**402, 406, 412, 416 S LUCILE ST  
SEATTLE, WA 98108**

DESIGN RECOMMENDATION REVIEW #1  
SDCI # 3039113LU  
March 14, 2023

**COMMERCIAL CONNECTION TO SIDEWALK**

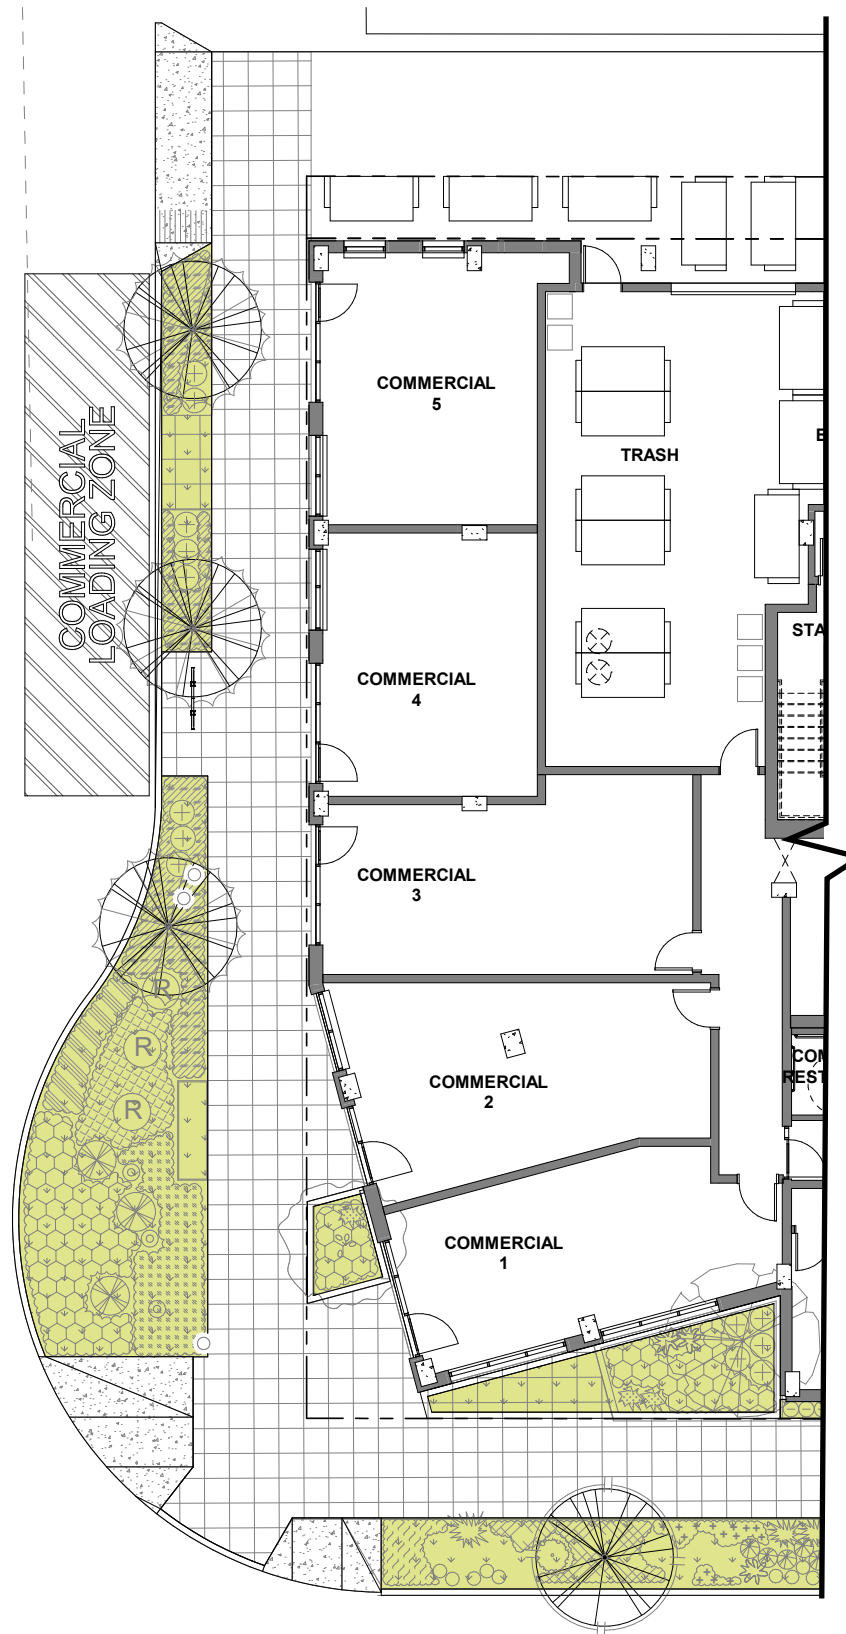
a. The Board supported the deeper setback proposed along the east side of the site along 5th Avenue S. and encouraged the design of the street frontage space to complement the residential lobby location through residential-supporting features like additional seating and landscaping (CS2-B-2 Connection to the Street, PL1-A. Network of Open Spaces, PL1-B. Walkways and Connections, PL3-A. Entries, PL3-B-1. Security and Privacy, DC3-B-1. Meeting User Needs).

Per the board's request, refined deeper setbacks to increase building massing definition, while updating residential entrance to project further out, providing better visibility to pedestrians, and intuitive direction on the formal entry. Wider glazed areas allow for full visibility and security, while built-in seating in the form of raised planters and site benches will be provided.

ACTIVITY AREA

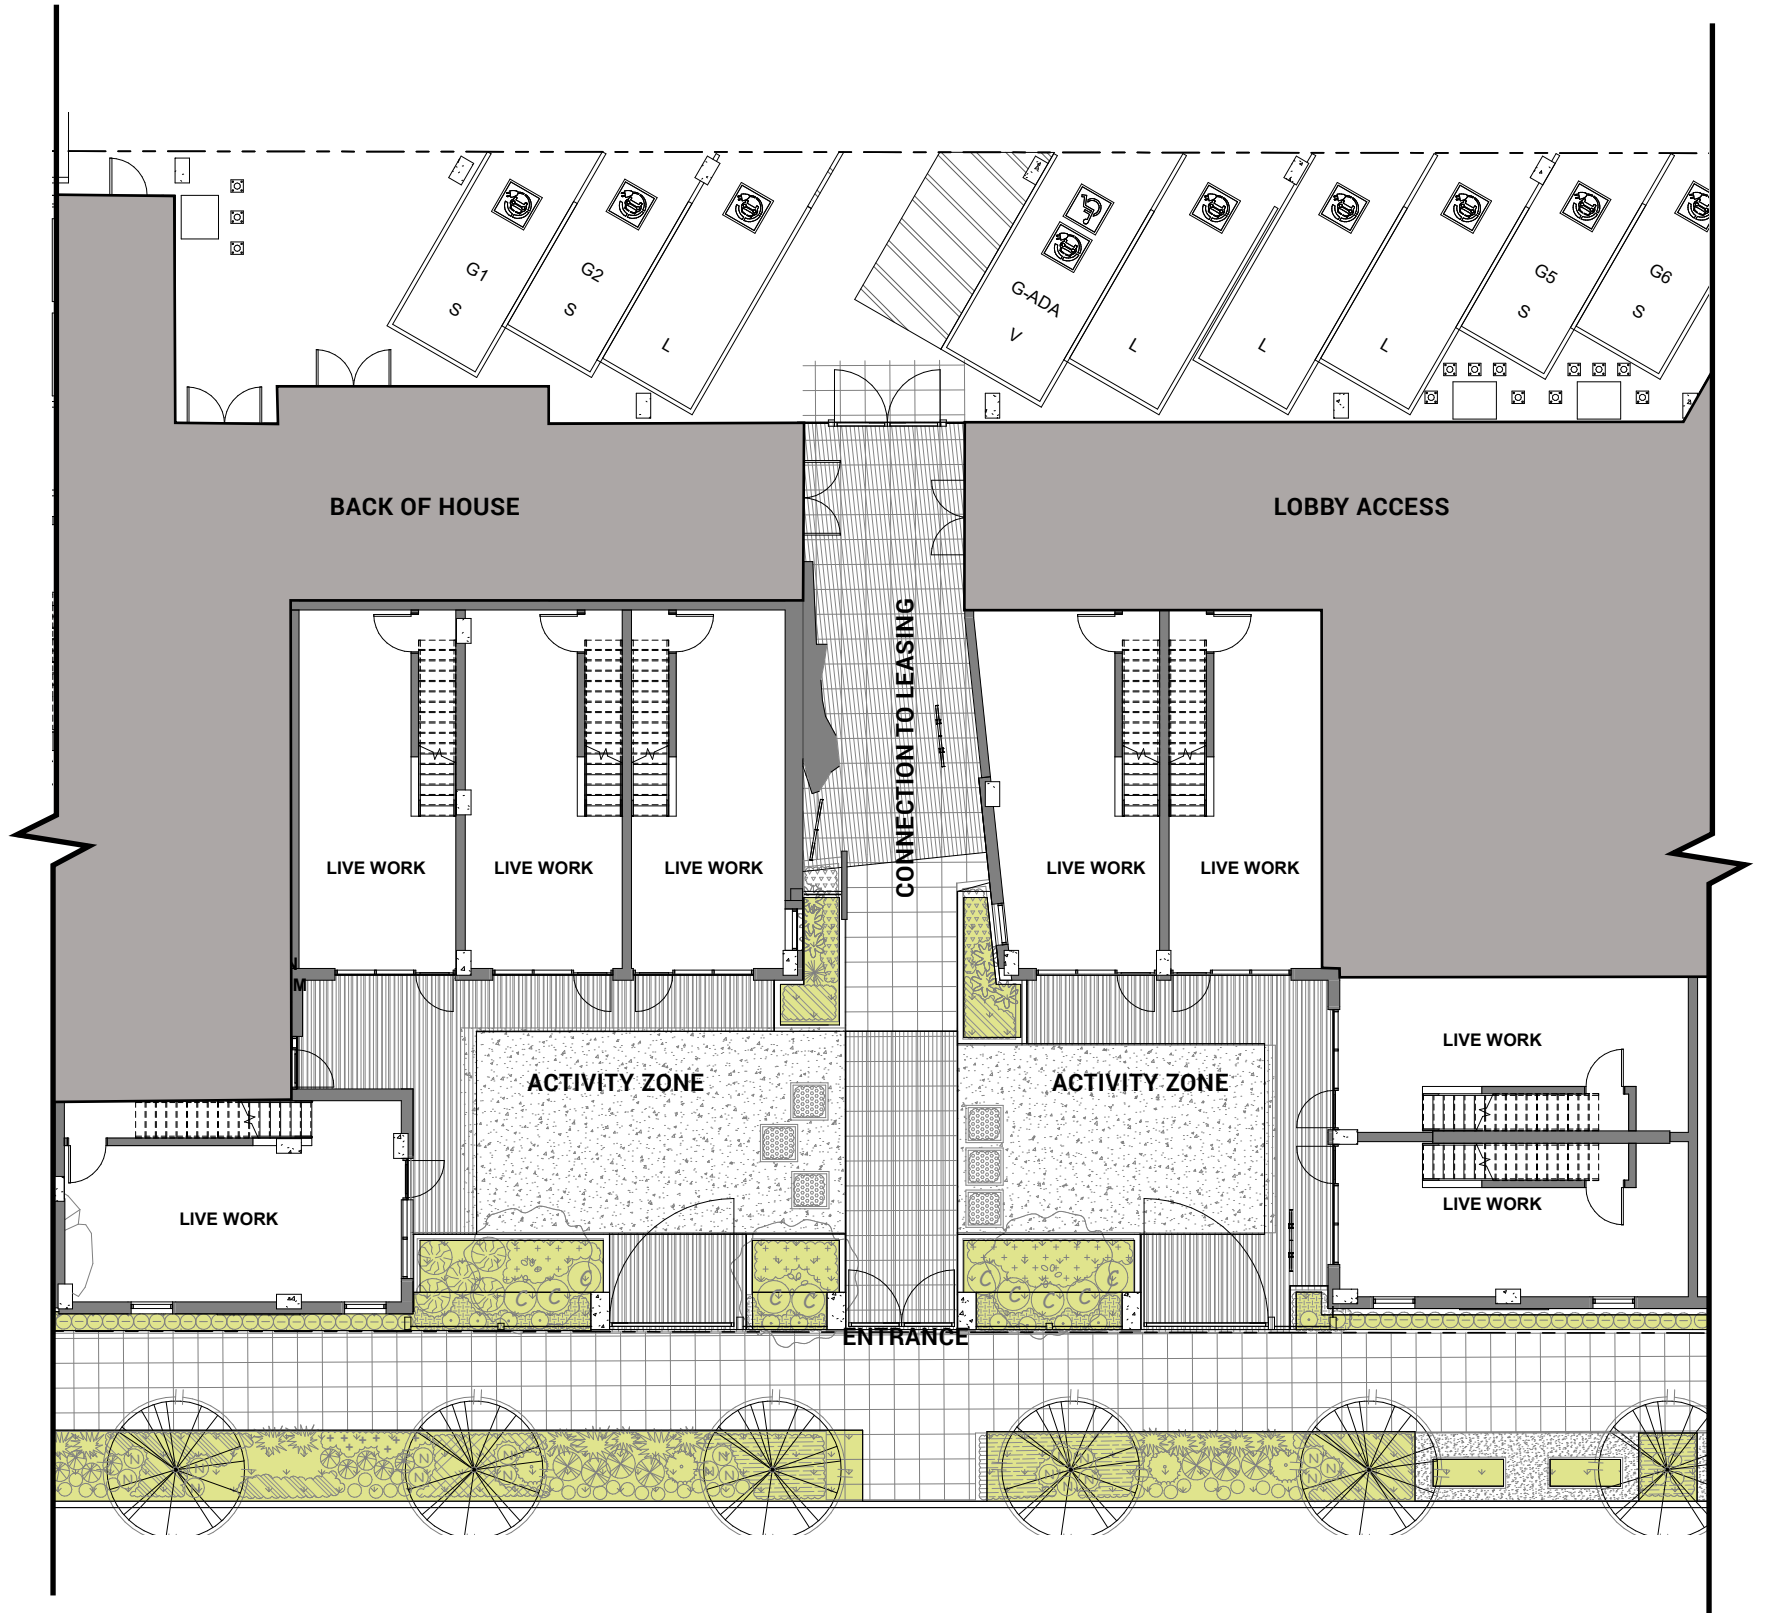
b. The Board emphasized the need for landscaping within the south-facing courtyard to soften the transition to building edges and to provide shade. The Board further encouraged the applicant to develop a landscaping plan that complements the intended function of the courtyard (CS1-B-3. Managing Solar Gain, DC3-A-1. Interior/Exterior Fit, DC3-C-2. Amenities and Features, DC4-D. Trees, Landscape, and Hardscape Materials).

In response to the board's recommendation, the design team emphasized the need for this south-facing courtyard to offer a level of transition and screening that identifies it as a uniquely shared amenity space, while still being porous enough to encourage passage through the site. The landscape is a mix of hardscapes and planters that offer a larger general-purpose zone for play, respite, or temporary installations similar to an art fair.

Defining the edge of the courtyard, an art-panel fence will complement the landscape by buffering the street and courtyard with a transparent and vegetated vertical plane, maximizing shade for the hotter months.

FLOOR PLAN LEVEL 1

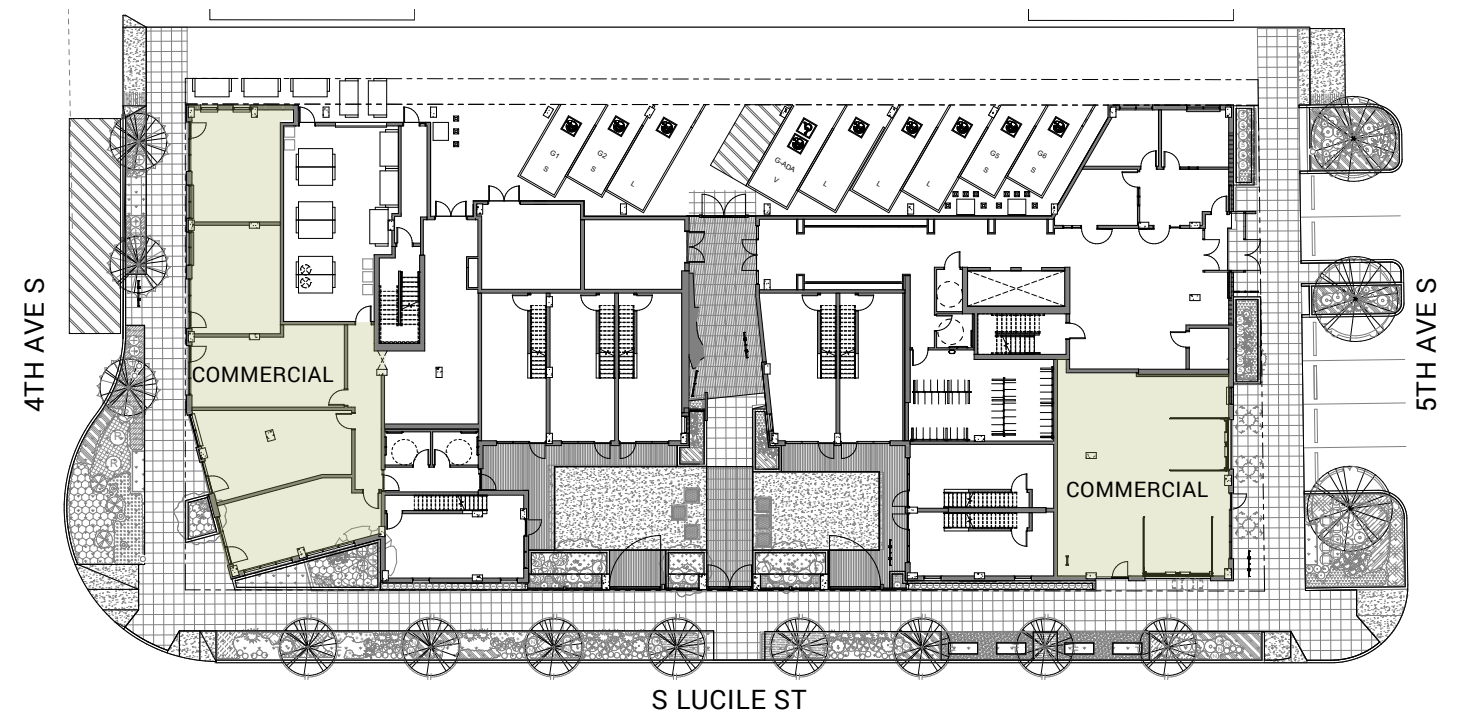
c. The Board questioned the strategy of using shallow areas of double-height ceiling heights along the street frontages in the commercial spaces to compensate for relatively short commercial ceiling heights, stating that the shallow depth of the double-height spaces generally do not appear to allow for sufficient commercial legibility and light to the spaces. The Board pointed to a conceptual section drawing of the southwest commercial space on packet page 51 as potentially having sufficient depth for commercial legibility and light but cautioned that façade detailing would also be important for commercial space legibility (CS1-B.1. Daylight and Shading, DC2-E-1. Legibility and Flexibility).

In response to the board's guidance, the design now incorporates areas of full-depth double-height spaces on the primary retail corners of the building. The use of these spaces is prescribed by the Watershed Community Development (WCD) organization, which intends to provide a mix of benefits, including a 'third-place' retail amenity on the Southeast corner. Where ceiling heights are requested to allow departures for additional affordable units, the commercial spaces are intended as artist studios, ranging in size and scale to allow for a mix of crafts and artisan storefronts.

PARTIAL REFLECTED CEILING PLAN (LIGHTING)

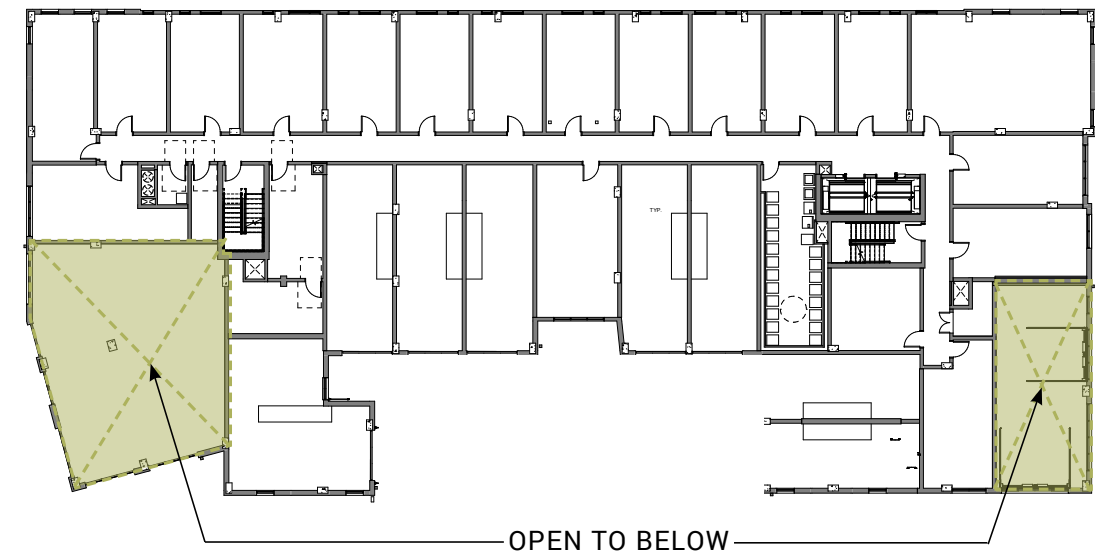
d. The Board expressed concern about the safety and security of the alley-adjacent parking area due to its low ceiling height and enclosure by the building on the east and west sides and requested additional attention to the safety and security of this space at the Recommendation phase of review. The Board specifically requested a lighting plan that includes this area (PL2-B. Safety and Security, DC1-C-4. Service Uses).

In response to the board's guidance, the design incorporates features that enhance the safety and security of the alley parking area including activation, lighting, and entrance features. The public art intended for this space will create a vibrant wall illuminated from above. Additional space had been identified such that service needs will not encroach on the public realm components, nor will trash or other waste be stored under the covered area, keeping sightlines open.

Section B: Proposed loading zone in between 4th Ave South and Commercial Bay 2/3

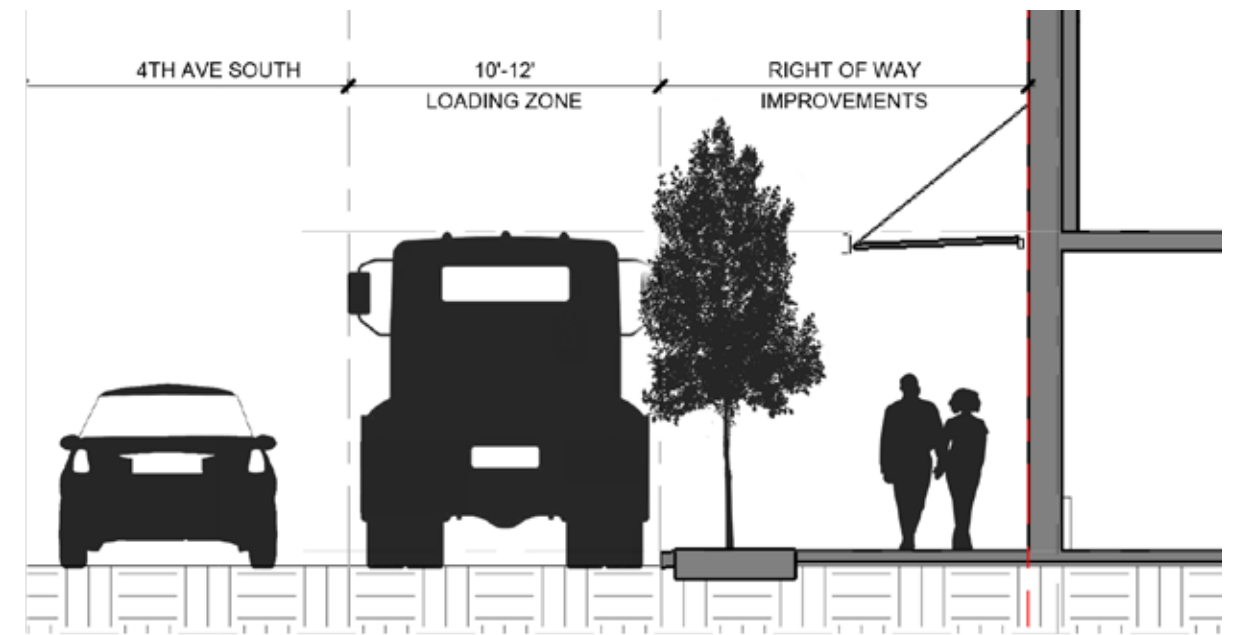
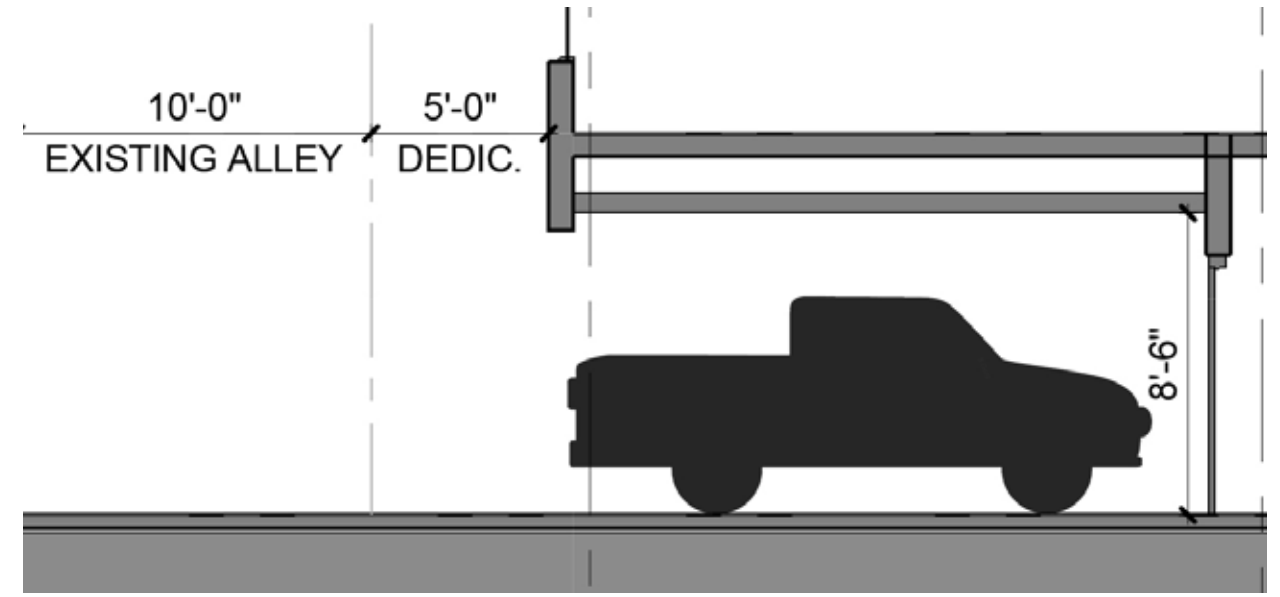
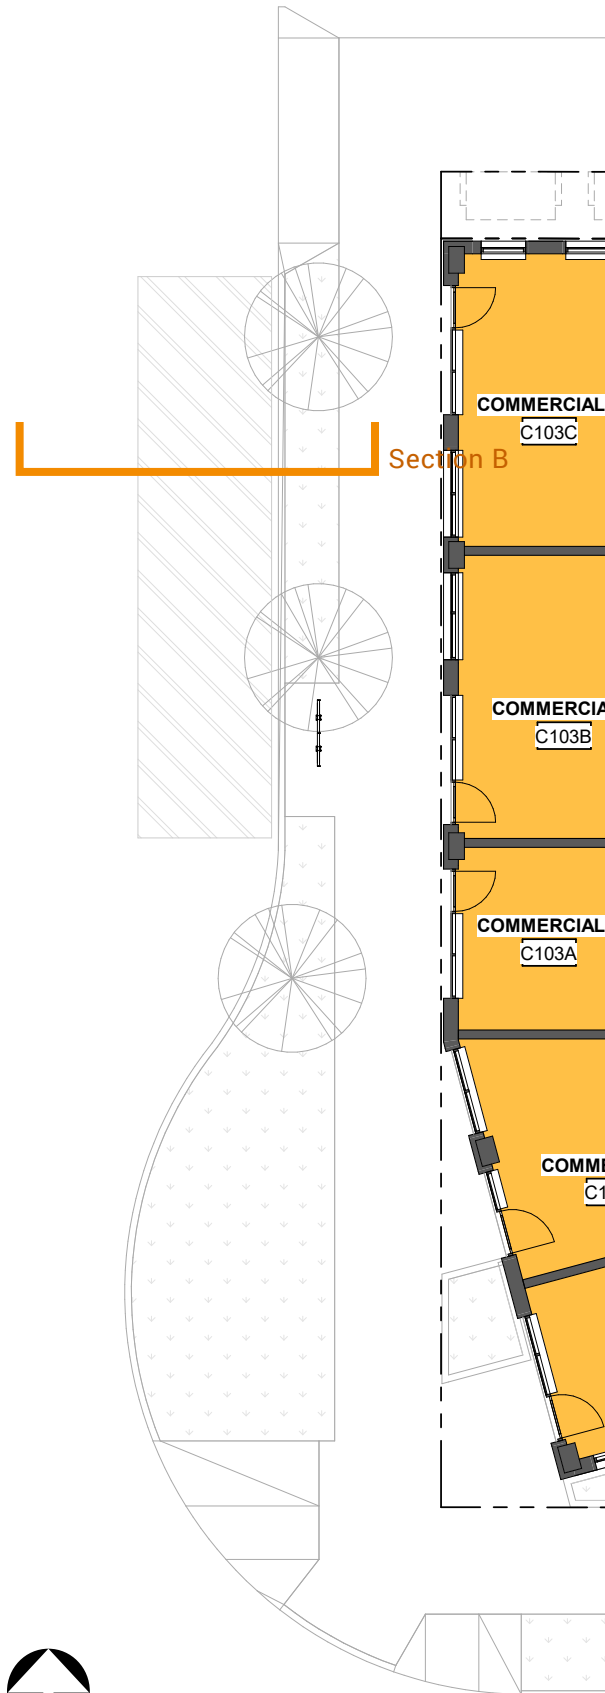
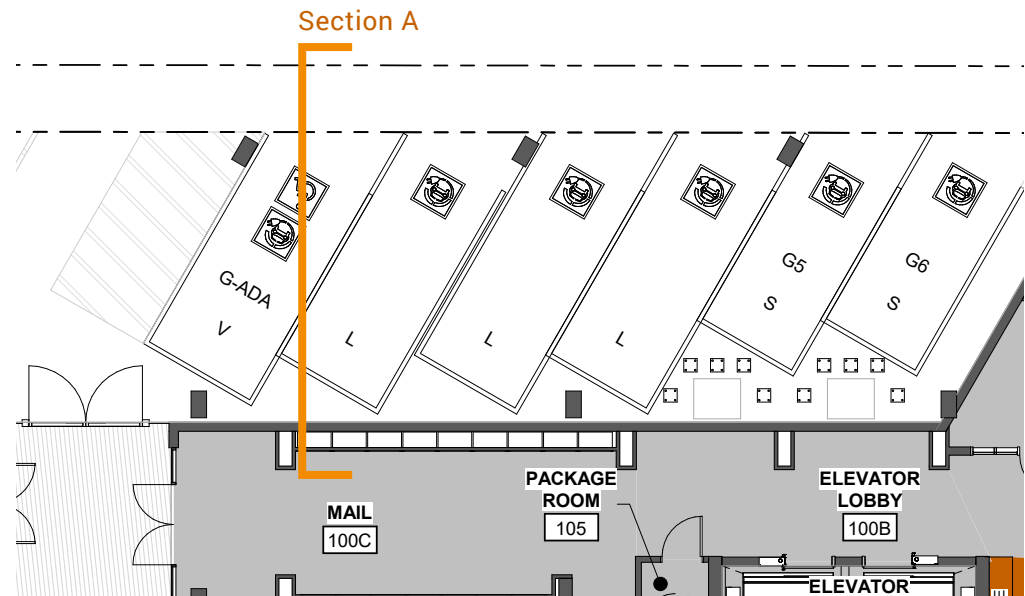
The Code requires a minimum vertical clearance of 14 feet. The applicant proposes a vertical clearance of 8'-4" for the required loading berth.

The Board did not indicate support for a loading zone height departure. The lack of a clear solid waste storage and staging strategy was cited by the Board as an important unknown factor that could impact this departure request because solid waste collection may require a taller loading height space. The Board also expressed concern about the safety and security in the parking area with the relatively short ceiling height, the enclosed nature of the space as shown in the packet, and the lack of lighting information for the space. The Board stated the need for a clear solid waste plan at the Recommendation phase of review for the consideration of this departure, as well as lighting information to aid in the safety and security of the alley-adjacent parking area (PL2-B. Safety and Security, DC1-C-4. Service Uses).

Solid waste collection plan and staging has been approved per SPU, with adequate uncovered staging in the alley proper. The height of the covered soffit below the transfer slab for Level 02 is constrained by the maximum 75' building height, while maximizing affordable unit counts in only seven levels of mixed unit types. Despite this, our design provides an 8'-4" maximum height restriction that will allow most consumer vehicles, including wheelchair accessible vans and SUVs. Should a vehicle be taller than this allowable height, the alley at 15' wide at its minimum constraint (28' if including adjacent clear maneuvering in the adjacent property) accommodates vehicle passing width.

Lighting of the area will be ample for both public safety, as well as to highlight covered mural planned for the exterior walls and columns within the covered parking deck.
